- A. Tract Map
- B. Behave Fire Spread Models
- **C.** Fuel Modification zone and fire wall matrix
- **D.** Typical section profile of fire wall and house
- **E.** Fire District letter of 8-11-08
- **F.** Letter from BHA, Inc to Vista Fire Protection District dated 4-14-09; with detail drawing of Cleveland Trail.
- **G.** Letters from Vista Fire Protection District dated 4-21-09 and 6-16-09
- **H.** Letter from DPLU/County Fire Authority Fire Marshal dated 6-3-09
- **I.** Illustrations of performance standards for structural components, in the Wildland Urban Interface.

RE: TM 5295 RPL 7 - SUGARBUSH

TM 5295 RPL-7 Sugarbush

Fire Protection Plan - incomplete

LETTER FROM BHA INC TO FIRE DISTRICT DATED 4-14-09, WITH DETAIL OF CLEVELAND TRAIL

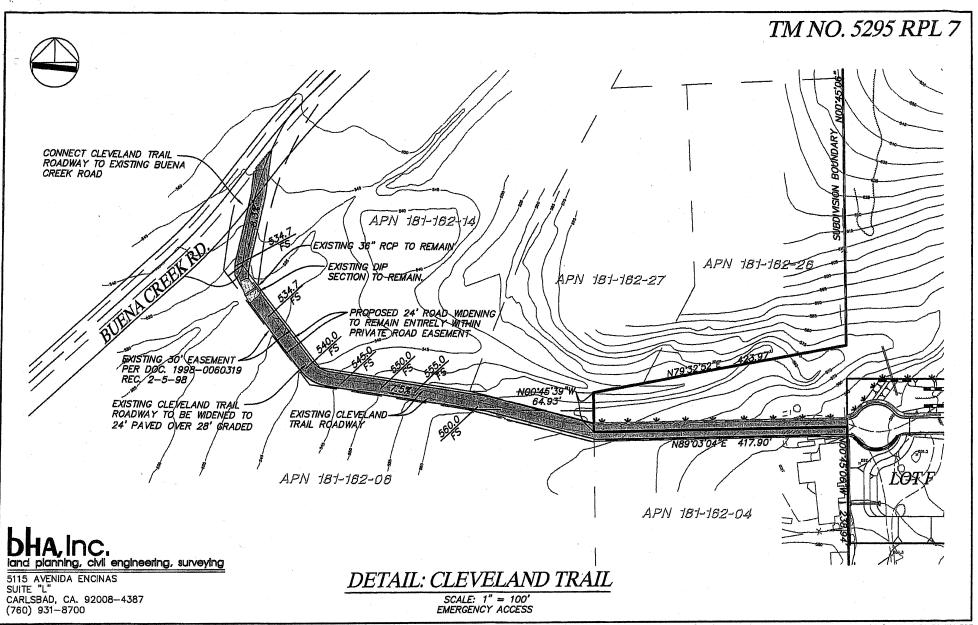
Pursuant to our meeting today, we are forwarding this letter and a drawing of the Cleveland Trail proposed improvements for your review and approval.

As we discussed, TM 5295 RPL 7 will be responsible for the widening of Cleveland Trail to twenty-four feet (24'). There is one exception to this and that is the crossing at Buena Creek, which will remain as is. The crossing is approximately fifty feet (50') long and approximately twenty feet (20') wide at its narrowest point.

The County of San Diego is allowing us to leave the crossing in its current state, but will need a letter from you supporting this condition.

I have reviewed your letter and the attached detail for Cleveland Trail road improvements dated April 14, 2009 (copy attached). It accurately summarizes our conversation related to the improvement of the Cleveland Trail crossing to Buena Creek Road.

Please accept this letter as confirmation that the Vista Fire Protection District will support the County of San Diego if they allow the crossing to remain in its current state.
